This Service Information bulletin supersedes SI B13 07 12 **dated May 2014.**

NEW designates changes to this revision

N63 and S63 Engine: High-pressure Fuel Injector Replacement Procedures

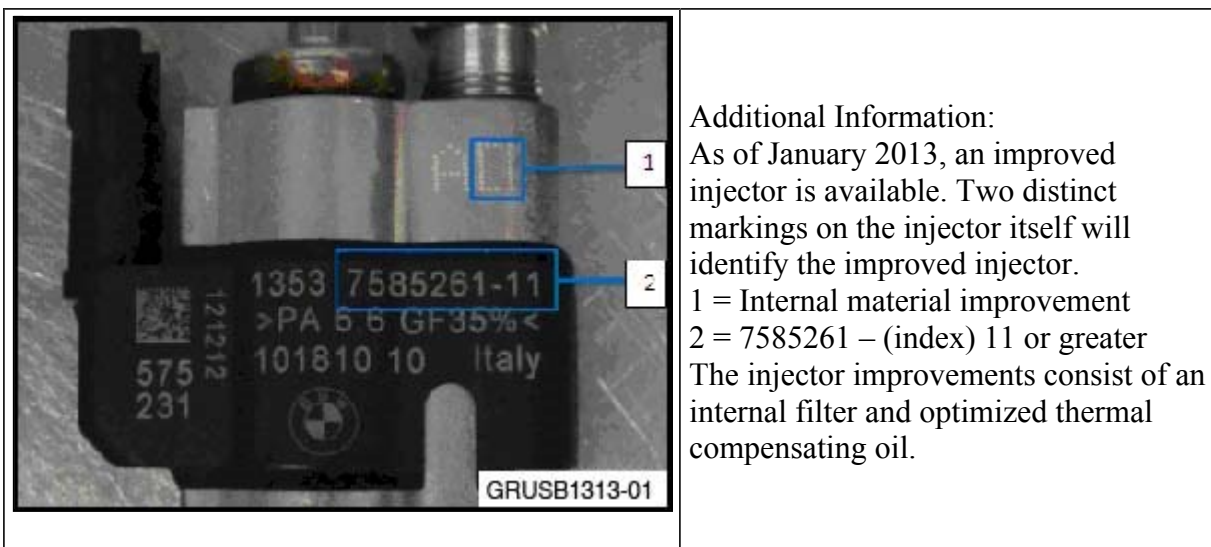
For example: If the engine has a misfire on cylinder 1, replace the injectors for cylinders 1-8 if those **injectors are not already index 11 or higher**.

If the **injectors** on that bank(s) are **already index 11 or higher**, only replace the injector on the faulty cylinder.

Use P/N **13 53 8 616 079** when replacing the injector(s).
